Corrigendum - 03 dated 21/08/2026 to CPC Tender No. BHEL/CPC/DRL/EPC_AHP/27/027

Work Description - EPC of Ash Handling System at 1X800 MW NTPC Darlipali Stage-II, Odisha

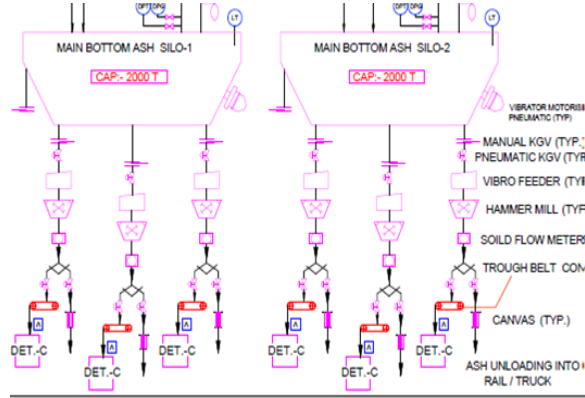
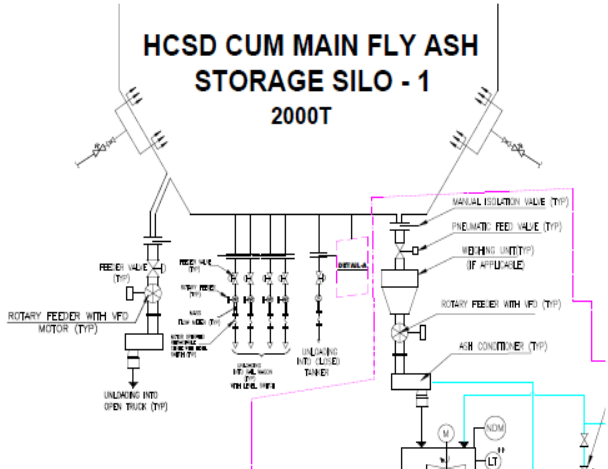
45	ANNEXURE-3 ELECTRICAL, C & I SCOPE MATRIX Clause No. 15	APH/ECO/DUCT/SCR Hopper High- & Low-Level switches and Level Transmitters	We propose to exclude the supply of ESP Hopper level instruments, JB, Cabling from instrument to field JB and ESP MCC to AHP DCS interfacing from Bidder scope. As ESP hoppers & ESP MCC is not in AHP bidder scope.	ANNEXURE-3 ELECTRICAL, C & I SCOPE MATRIX is clear. Bidder to follow specification. Revised Annexure 3 is attached with this Corrigendum.
46	ANNEXURE-3 ELECTRICAL, C & I SCOPE MATRIX Clause No. 5(5)	24V DC and UPS system (UPS load and 24V DC load applicable to BHEL free supplied equipments shall be shared to successful bidder during detailed engineering by BHEL-EDN. Bidder to size the rating of UPS and DC system considering the	We propose to exclude the supply of 24V DC and UPS system from AHP Bidder scope since DCS is in BHEL scope.	ANNEXURE-3 ELECTRICAL, C & I SCOPE MATRIX is clear. Bidder to follow specification. Revised Annexure 3 is attached with this Corrigendum.

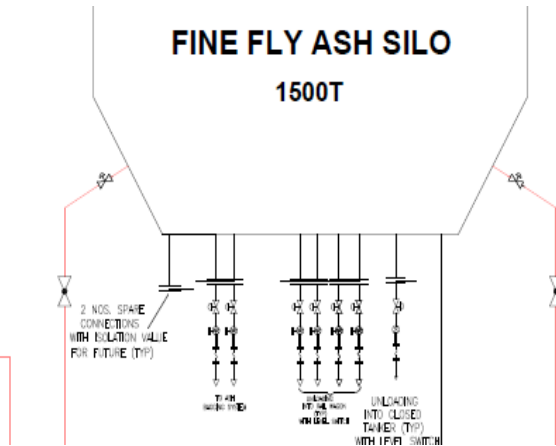
49	General	General	We request the General Arrangement (GA) Drawing, showing Plan & Elevation for the ECO, ECO DUCT, APH and DUCT Ash Hoppers alongwith their positions w.r.t. the nearest platform. Additionally, please provide the expansion details for each Ash Hopper.	The details shall be provided during detailed engineering.

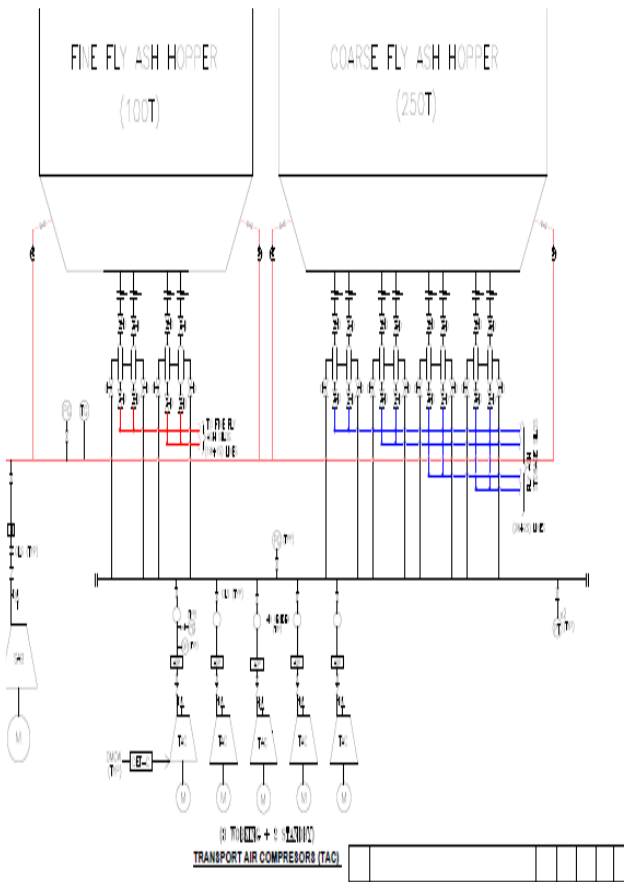
Sl. No.	Reference clause of Tender Document	Existing provision	Bidder's Queries	BHEL Reply
		 The diagram illustrates the internal layout of a 1500T Fine Fly Ash Silo. It shows a central storage area with multiple hatches for access. Key features include: 2 NOS. SPARE CONNECTIONS WITH ISOLATION VALVE FOR FUTURE (TYP): Indicated on the left side of the silo. TO WH (WHICH TYPE): A connection point at the bottom left. UNLOADING INTO CLOSED TANKER (TYP) WITH I/P (I/P) SWITCH: A connection point at the bottom right. INTERNAL STRUCTURE: Shows various internal components, including what appears to be a telescopic spout mechanism.	envisaged that "The pitching of ash silo and overall arrangement of hydro-mix conditioner units, telescopic chutes, air slides etc shall facilitate simultaneous loading of wagons (BOXXN/ BCFC/ BCCW/ BTAP) from all the BA storage silo (in case of dry bottom ash system only) and HCSD cum main fly ash storage silos. Suitable positioning arrangement for Control of movement of Telescopic spout shall have to be provided in all three X-Y-Z directions to facilitate loading of ash into Wagons. While loading ash in wagons, top lids of wagons need to be accessed. For ensuring safety while accessing the top of wagon, a suitable platform at approx. height of 4.5 Mtrs above railway track all along the length of track in silo area shall be provided."In this regard,1) Please confirm the number of Rail Wagons to be considered below each above silo.2) please confirm the number of hatch openings to be considered in each type of Rail Wagon.
